STAFF REPORT: 04/10/2024 REGULAR MEETING

**APPLICATION NUMBER:** HDC2024-00087

ADDRESS: 232 W GRAND RIVER (1400 WASHINGTON BLVD)

**SCOPE:** ALTER STOREFRONT (WORK COMPLETED WITHOUT APPROVAL)

Figure 2, by Applicant: Proposed elevations showing new entry and storefront while retaining existing cast-iron trim.

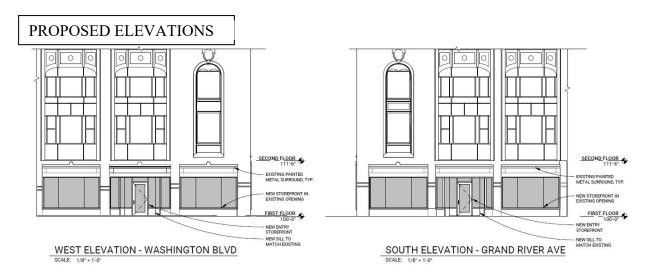
designation, it is staff's opinion that retention of historic fabric is of greater importance than its geometry.

This proposal incorporates historic material still remaining from an unapproved alteration with a modest change in the entrance's geometry, restoring a recessed entry condition while accommodating universal access.

• The proposed features do not conflict with the Elements of Design in materials or design.

- Staff has no issues with the proposed plan.
- The violating scope identified in this report, but not yet addressed by the property owner, has been referred to BSEED for enforcement.

It is staff's opinion that the project generally conforms to the Elements of Design for the district and meets the Secretary of the Interior's Standards for Rehabilitation. Staff therefore recommends that the Commission issue a Certificate of Appropriateness as proposed.
